PCN Title: Additional Qualified (AT) Assembly Test Site - SIMAT

**PCN-2480 REV 1**

Notification Date:	Implementation Date:	Product Family:	Change Type:	PCN #:
21 October, 2020	21 January, 2021	Analog Semiconductors	Additional Qualified (AT) Assembly Test Site SIMAT	<b>2480</b>
TITLE				
Additional Qualified (AT) Assembly Test Site SIMAT				
DESCRIPTION OF CHANGE				
<p>This PCN is being issued to notify customers that in order to assure continuity of supply, Diodes has qualified an additional AT site (SIMAT) located in Shanghai China.</p> <p>Full electrical characterization and high reliability testing has been completed to ensure there is no change to device functionality or electrical specifications in the datasheet. Refer to the attached qualification / reliability report (embedded in this file).</p> <p>Package Outline Differences are listed in Table 1A.</p>				
IMPACT				
Continuity of Supply. No change in data sheet electrical parameters and product performance.				
PRODUCTS AFFECTED

Table: 1A - Package Outline Dimension (POD) Comparison SAT vs. SIMAT

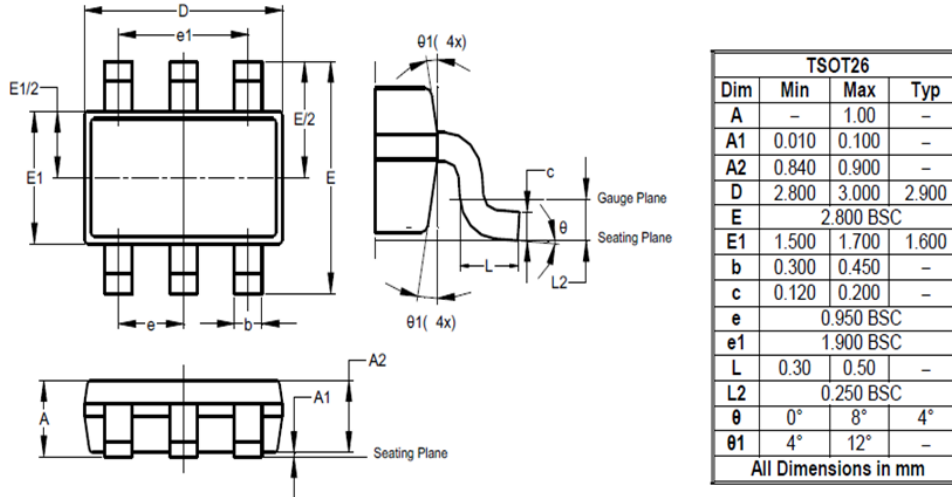
Dimension	Old A/T site SAT	New A/T site SIMAT	Pkg Type
D	Min 2.8 mm, Max 3.0 mm, Typ. 2.9mm	Min 2.82mm, Max 3.02mm, Normal 2.92mm	TSOT23-5/TSOT23-6
E	2.8mm BSC	2.8mm Normal	TSOT23-5/TSOT23-6
A2	Min 0.84mm, Max 0.90mm	Min 0.70mm, Max 0.80mm	TSOT23-5/TSOT23-6
